HISTORIC AND DESIGN REVIEW COMMISSION

August 15, 2018

HDRC CASE NO: 2018-394
COMMON NAME: 229 LINDELL PL
LEGAL DESCRIPTION: NCB 6529 BLK 1 LOT 1
ZONING: R-4, H, RIO-1
CITY COUNCIL DIST.: 1
DISTRICT: River Road Historic District
APPLICANT: Joshua Sutton
OWNER: Joshua Sutton
TYPE OF WORK: Amendments to a previously approved design for construction of a single family residential structure
APPLICATION RECEIVED: July 27, 2018
60-DAY REVIEW: September 25, 2018
REQUEST:

The applicant is requesting a Certificate of Appropriateness for approval to amend a previously approved design for new construction. Within this request, the applicant has proposed the following modifications:

3 GARAGE ELEVATIONS
SCALE: ¼"=1'-0"

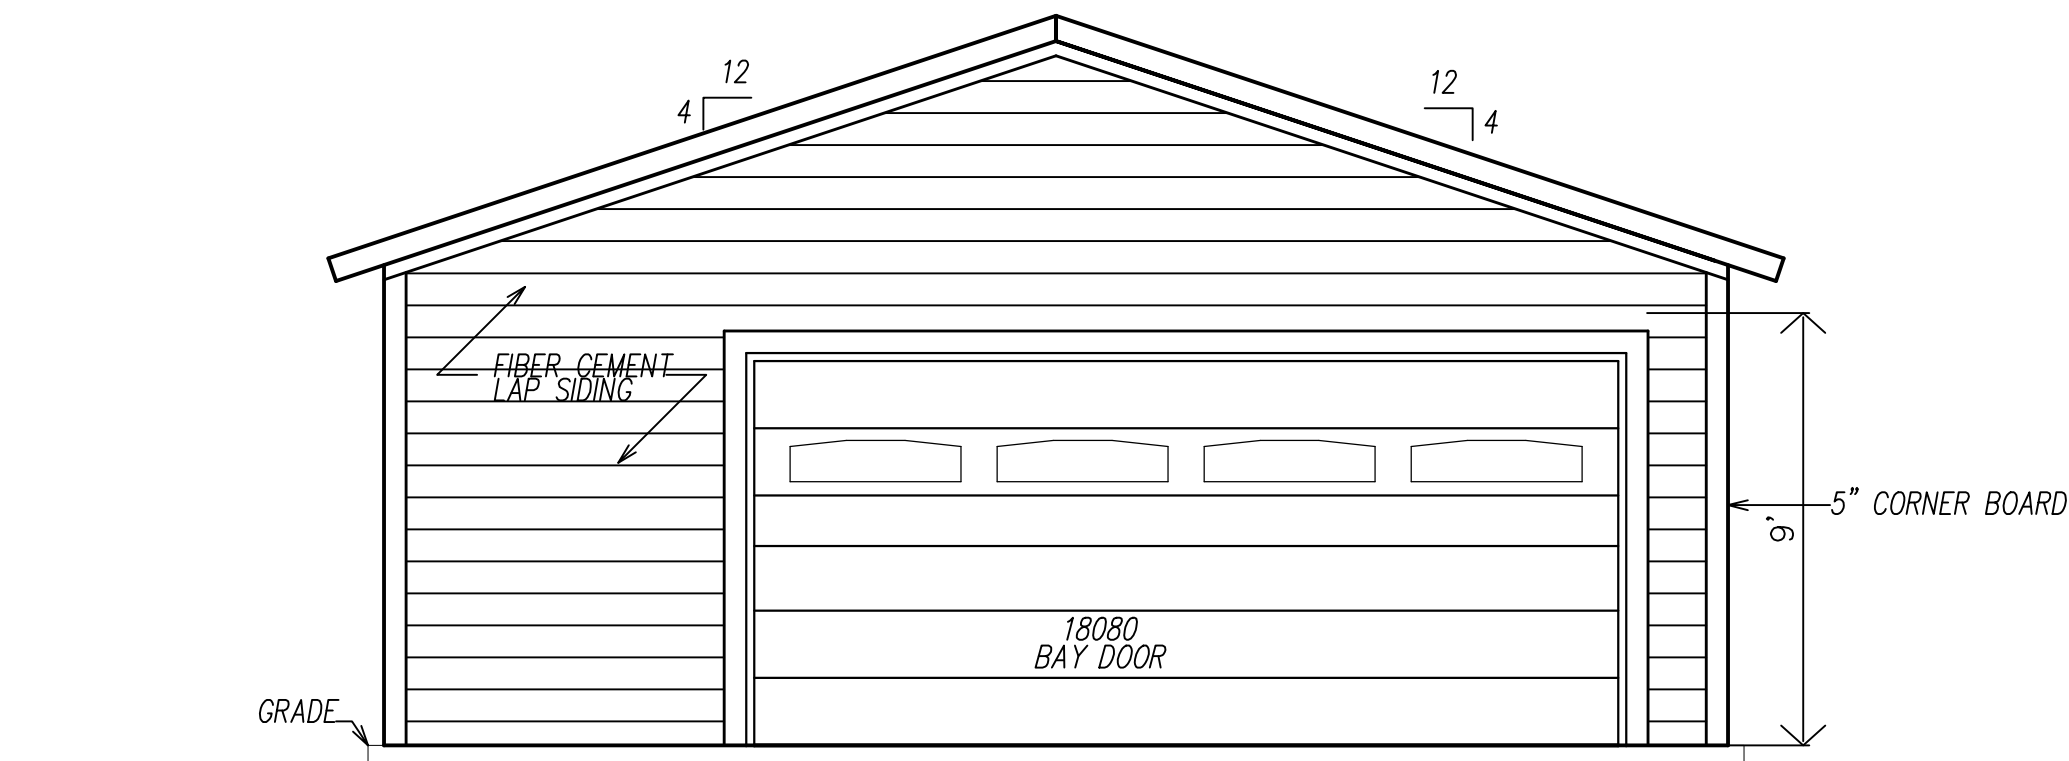
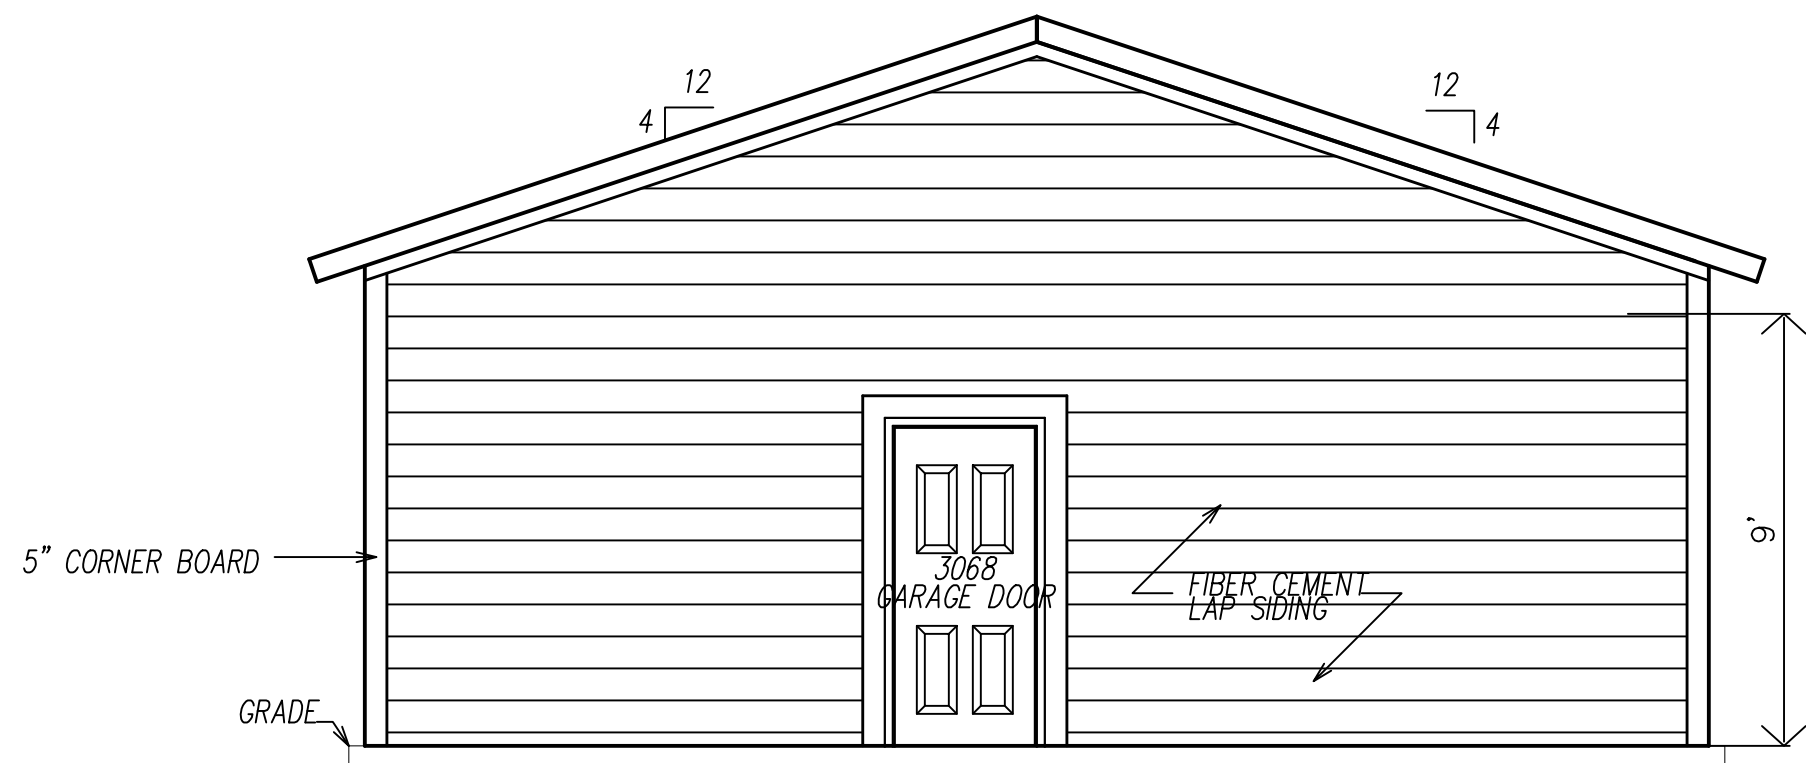
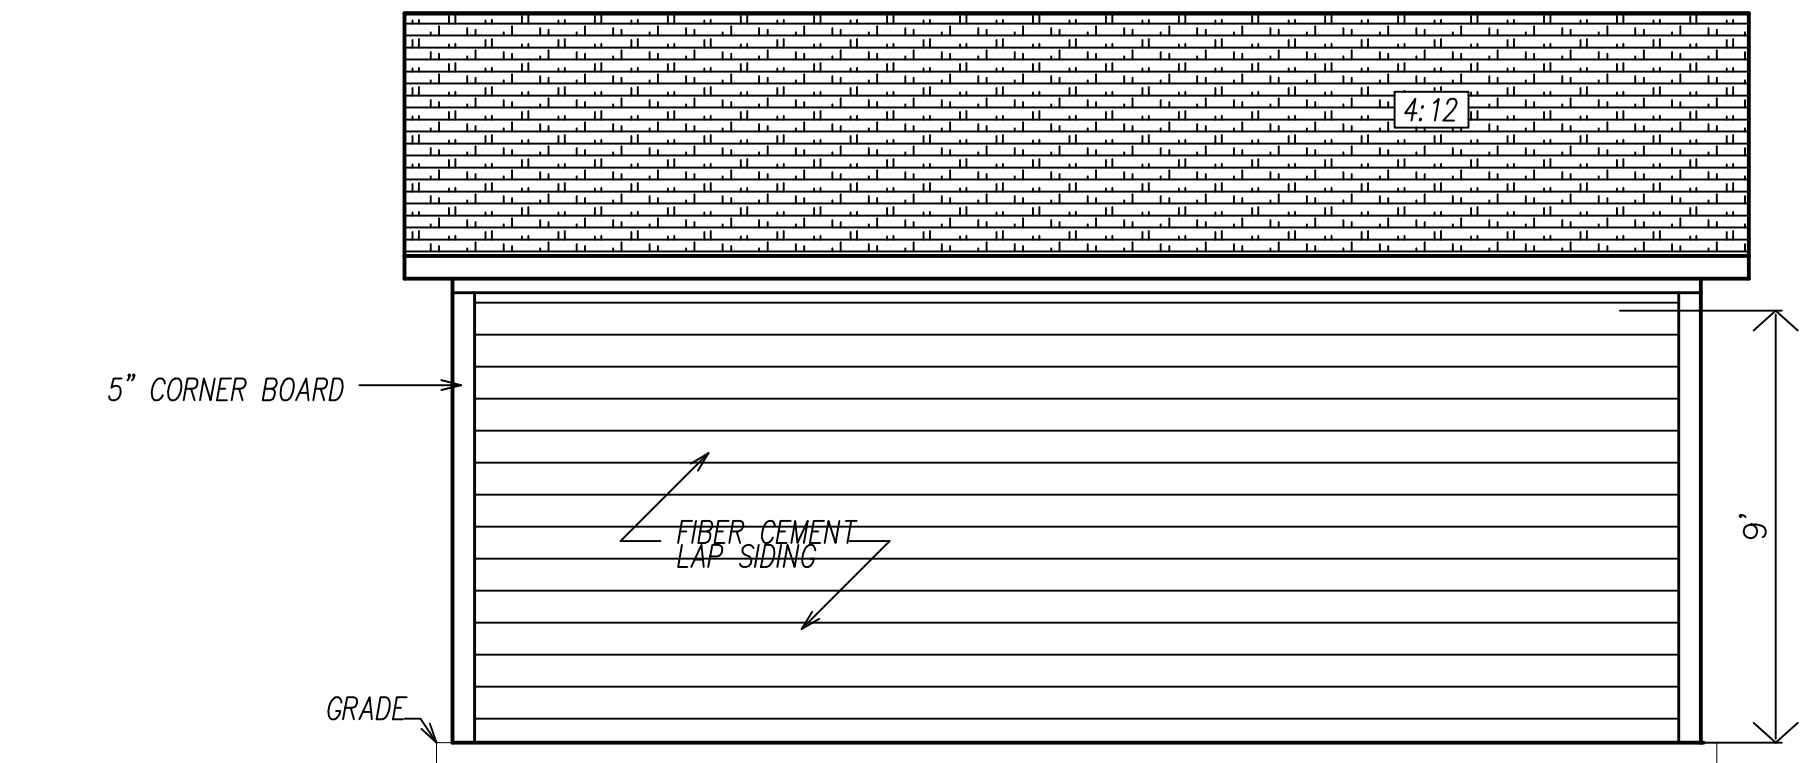
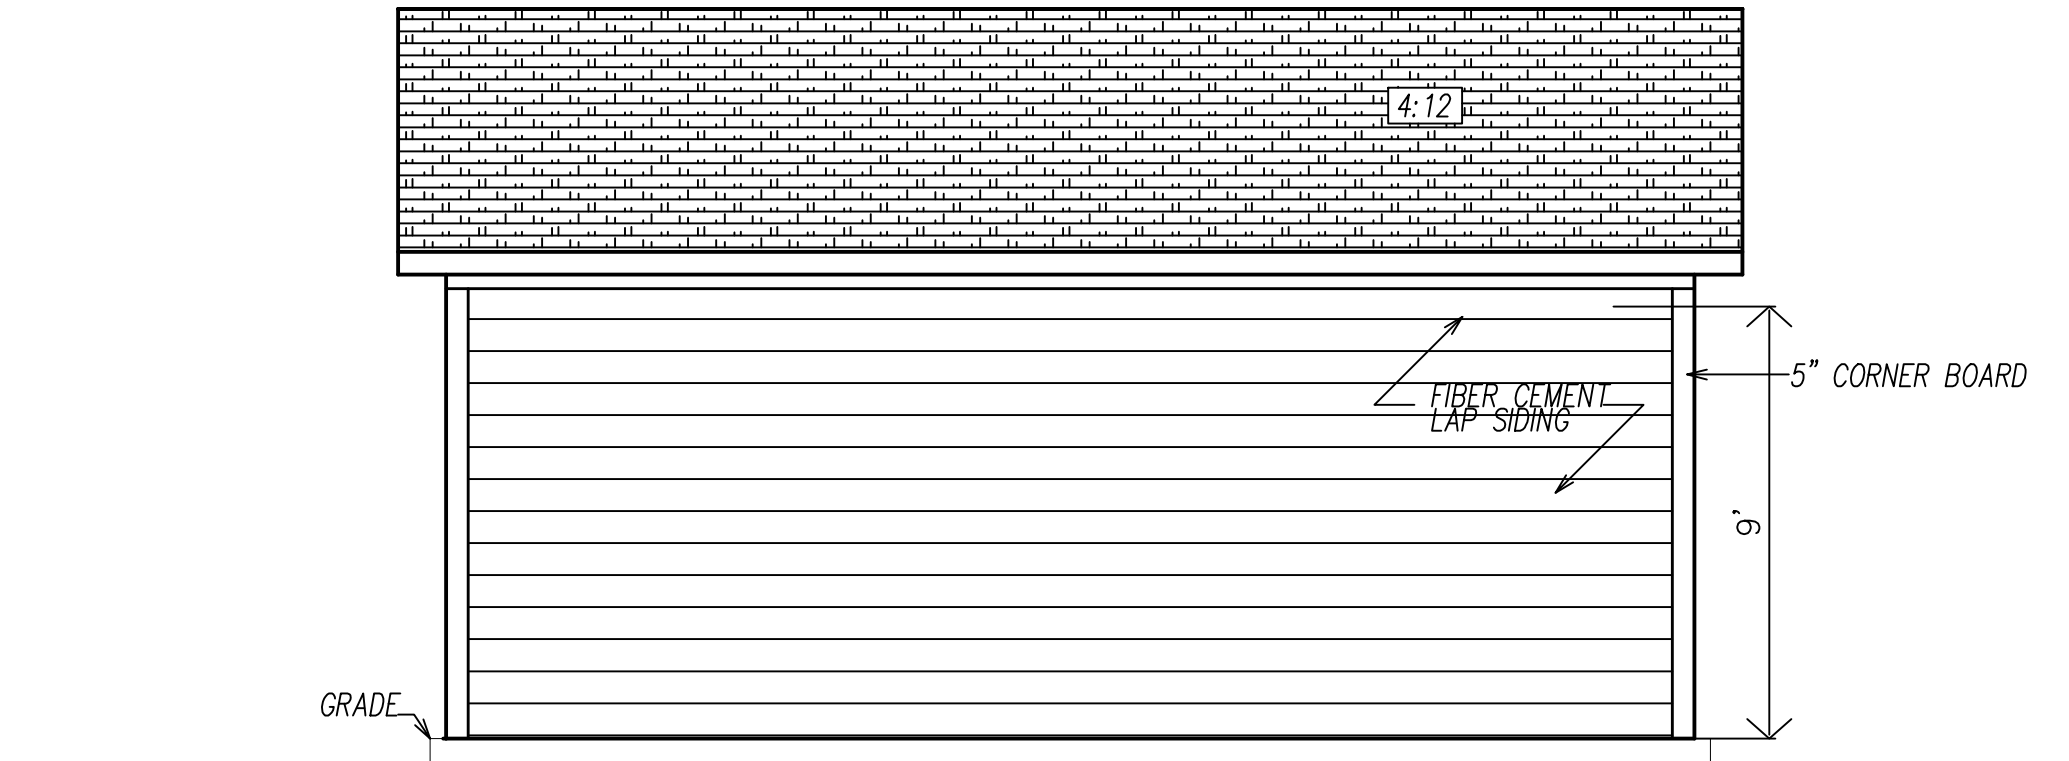
- e. ACCESSORY STRUCTURE – The previously approved accessory structure featured a footprint of 24' x 22'. At this time, the applicant has proposed to increase the size to 28' x 26'. Staff finds the proposed increase in size to be appropriate. Staff finds that two separate garage doors that are not vinyl should be installed.

- ii. That the proposed Hardie siding feature an exposure of four (4) inches.
- iii. That the proposed accessory structure feature two garage doors that are wood or aluminum in material.
